Plunket Park

Plunket Park is large neighborhood park that provides parking, ballfield, picnic tables, playground and restrooms. The main issues at this park are not properly designed accessible parking spaces, not enough accessible parking spaces, slopes too high, protruding branches, abrupt transitions, and various elements in the restrooms not accessible. **Please Note:** When a **UD** is indicated, this is a Universal Design (**UD**) recommendation to enhance accessibility. The **UD** recommendation is not required to meet the minimum accessibility standards but it would be encouraged. When engineered wood fiber is provided at playgrounds provide a regular maintenance of the surface to maintain an accessible surface.

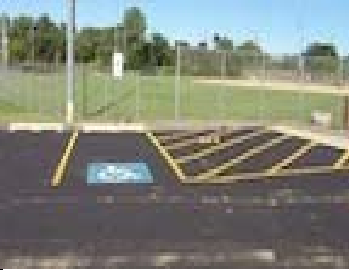
The women's restroom door has a opening force too high at 13 lbs. and closes too quickly at 4 seconds.	IAC 400.310(j)(10)(B)(i)	Adjust the closer so the door opening force is no heavier than 8.5 lbs. to open and takes a minimum of 5 seconds to close or provide an automatic door opener at one of the doors		Bob Byrne	\$100	2013	Adjusted to opening force of 7.5 lbs. closing speed adjusted to 7 sec. 3/2013

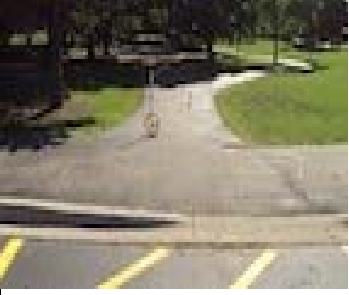
Photo	Barrier	ADAAG/IAC	Solution	Priority	By Whom	Projected Cost	Projected Date	Action Taken
	The faucets in the women's restroom shut off too quickly at 1 second.	ADAAG 606.4	Provide a lever-operated, push-type or electronically controlled faucet. Self-closing faucets should remain open for at least 10 seconds. Push-type or lever-operated faucets should require not more than 5 lbs. to operate.			\$550	2019	
	The mirror is mounted too high at 41" to the reflective surface.	ADAAG 603.3	Lower the mirror above the sink or countertop to be no higher than 40" to the reflective surface. Mirrors not mounted above the sink or a counter top should be mounted no higher than 35" to the reflective surface. UD - A full-length mirror would be a recommended option.		Bob Byrne	\$550	2013	Men's lowered to 40 1/8" (max. available); women's lowered to 40 1/4" max. available 3/13
	The rear and side grab bars are mounted too high at 37".	ADAAG 4.17.6	Provide grab bars that are mount between 33" to 36" to the top of the grab bar.		Bob Byrne	\$100	2013	Remounted side bar to 36" AFF - 3/2013

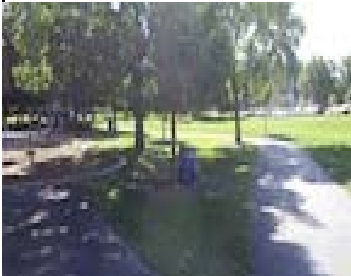
Photo	Barrier	ADAAG/IAC	Solution	Priority	By Whom	Projected Cost	Projected Date	Action Taken
	The tampon disposal in the women's restroom is mounted too far from the toilet at 17".	ADAAG 308	Relocate the tampon trash can to be no more than 9" maximum in front of the toilet if mounted on the sidewall or no more than 20" from the toilet if mounted on the back wall. The tampon trash can should be mounted no higher than 48" on either wall.		Bob Byrne	\$100	2013	Remounted disposal on rear wall at 19" from center of toilet 25 1/2" AFF 3/2013
	The coat hook in the women's restroom is mounted too high at 53 1/4" AFF.	ADAAG 308	Lower the existing coat hook or add a second coat hook at 48" AFF.		Bob Byrne	\$100	2013	Remounted hook to 48" AFF 3/2013
	The baby changing table is mounted too low 22 3/4" for the knee space and 24 1/2" to the changing surface.	IAC 400.320(w)	Remount the baby changing table to be no higher than 34" AFF and provide a minimum knee clearance of 27". Also mount it so the handle is no higher than 48" AFF.		Bob Byrne	\$250	2013	Remounted table to 27" knee clearance; 29" table height and 43" handle height AFF 3/2013

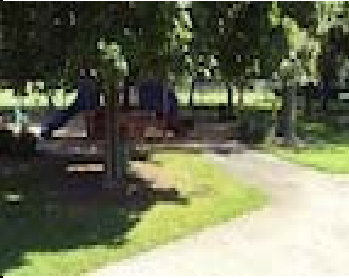
The walkway from the accessible parking space to the park walkway has a cross slope too steep at 2.6% to 8.8% for 75'.	ADAAG 403.3	Remove and regrade section to provide a cross slope no greater than 2%.			\$2,475	2020
